PLANNING DEPARTMENT – Development Review Services

**RE: South Los Altos Children's Park  
Grading & Drainage Plans  
Engineer's Stamp Date 8-04-2015 (File: K20D062)**

SOUTH LOS ALTOS CHILDREN'S  
GRADING AND DRAINAGE PLAN

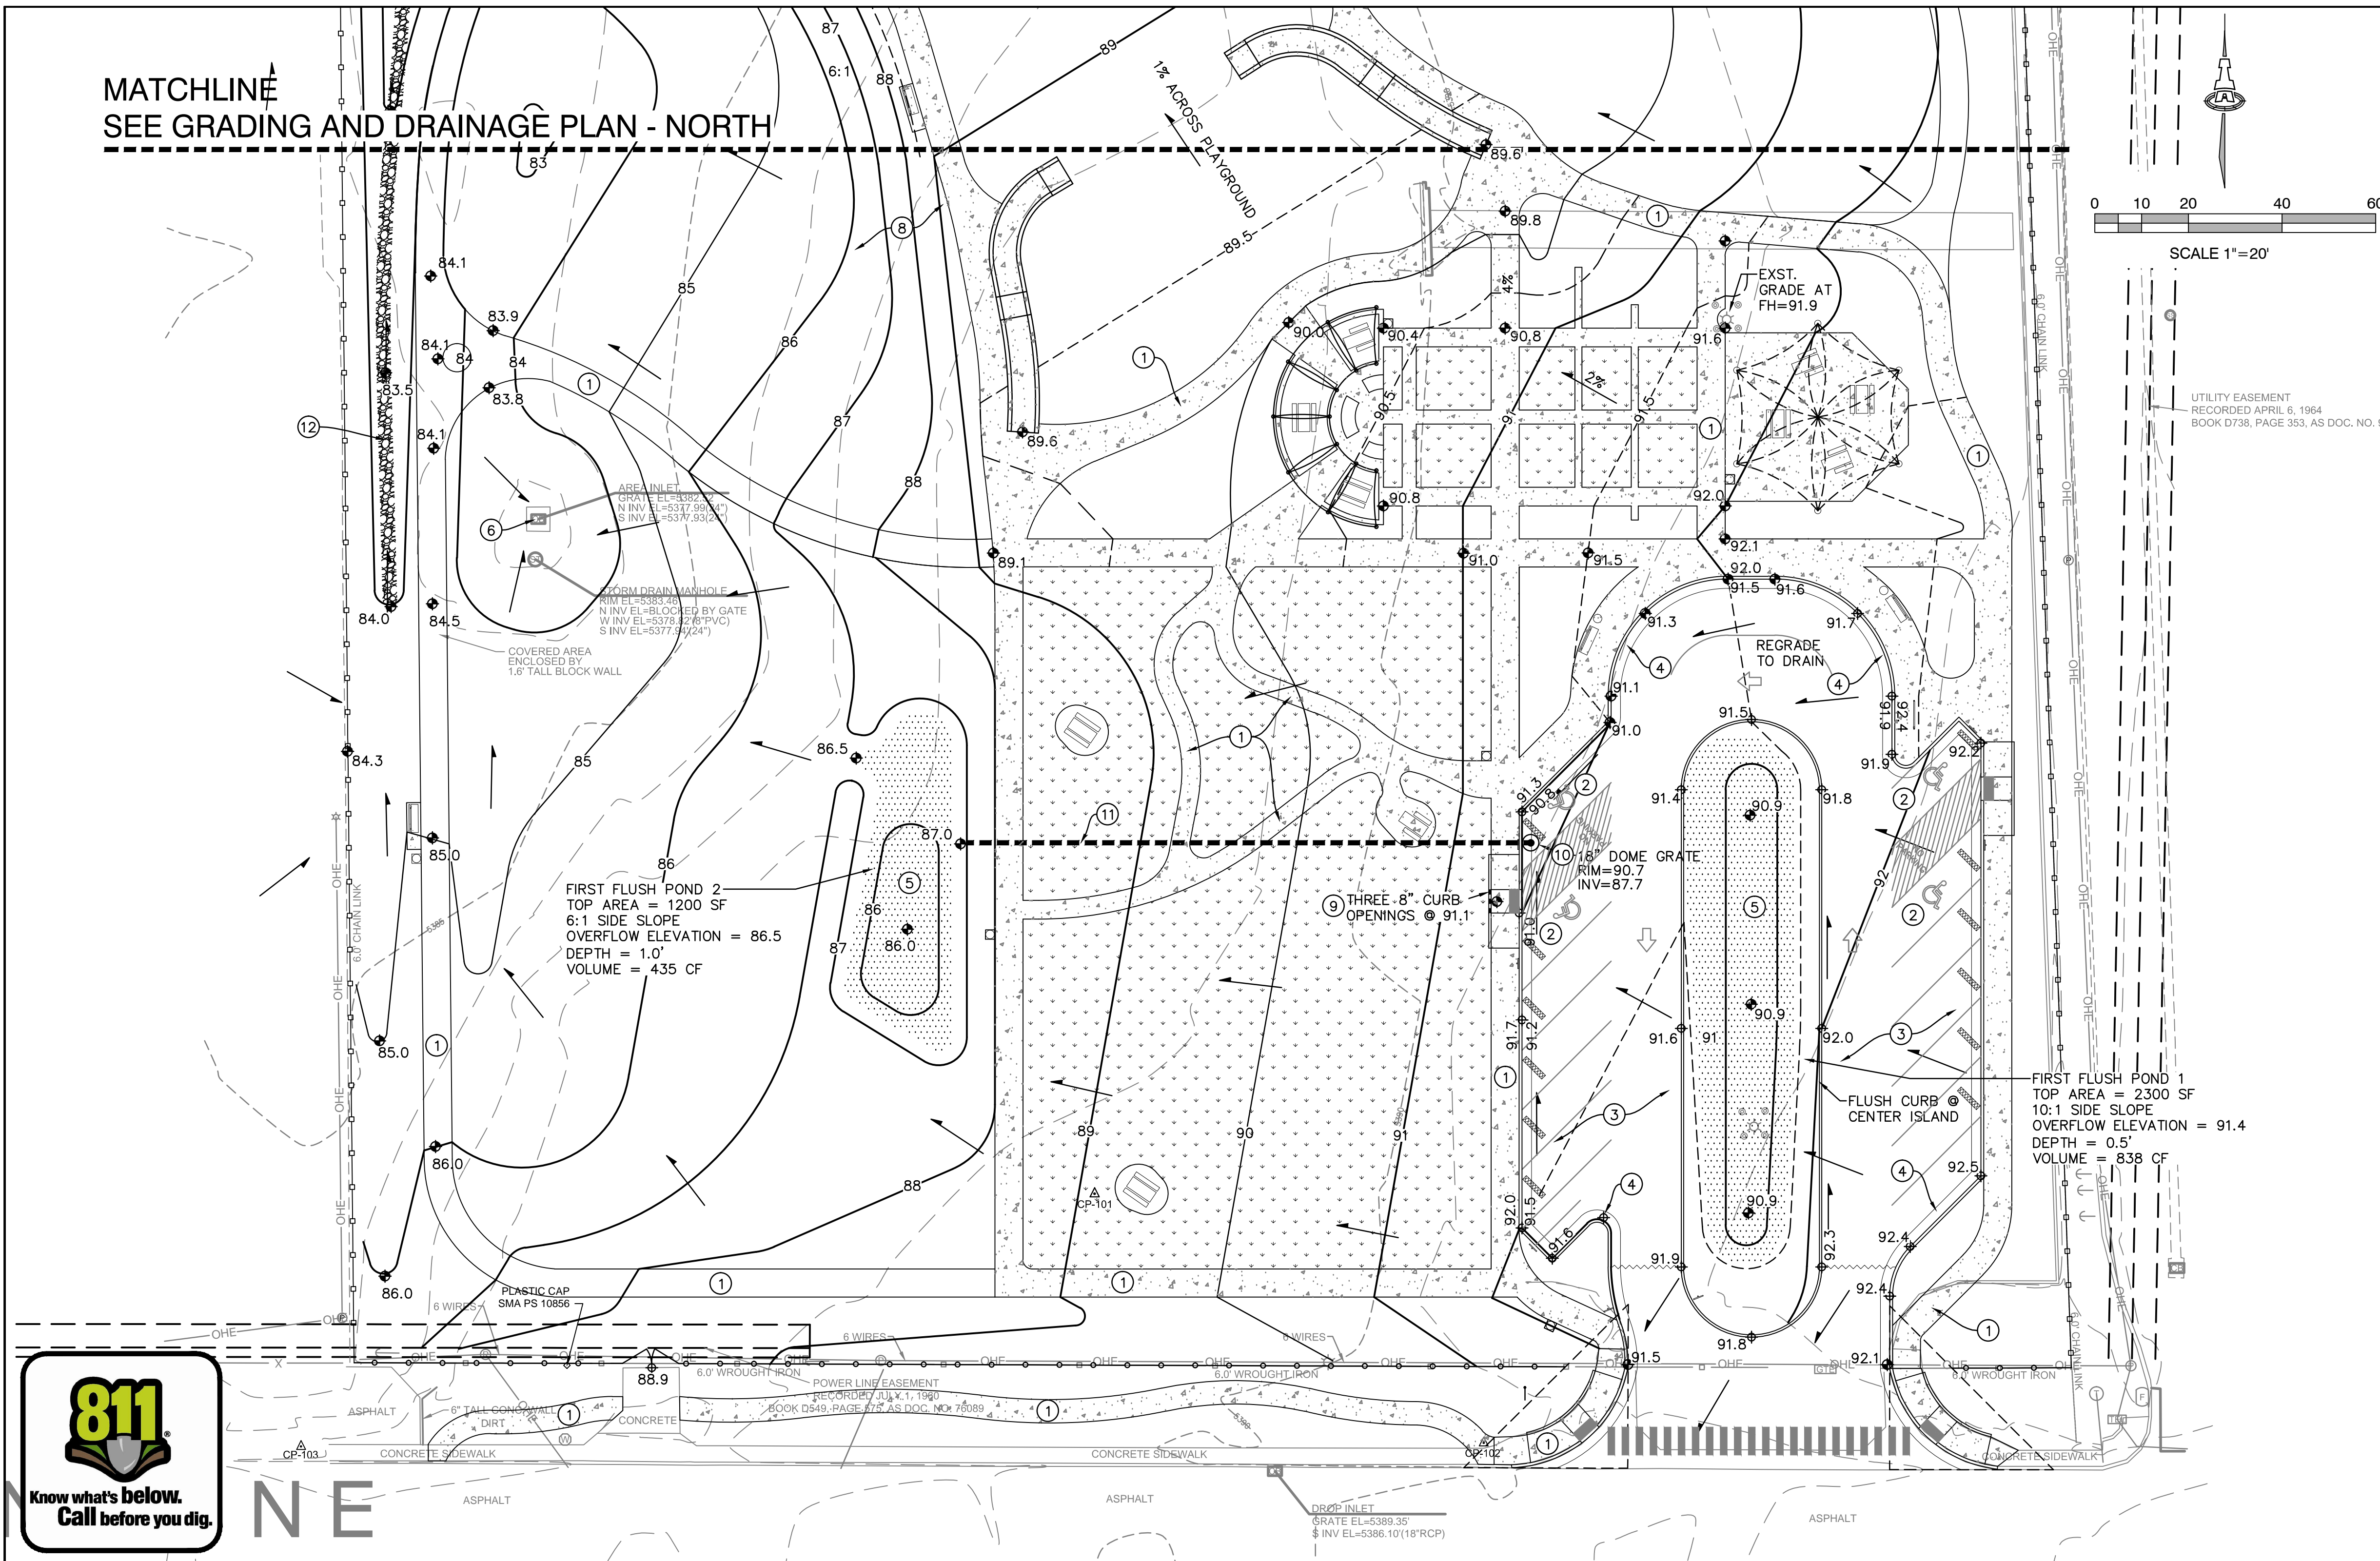
The platting action associated with this site will require a cross-lot drainage easement to accept offsite flows from the west and north. It is noted that flows from the east do not enter this site.

Prior to Grading Permit approval, show the existing storm drain system on the plan.
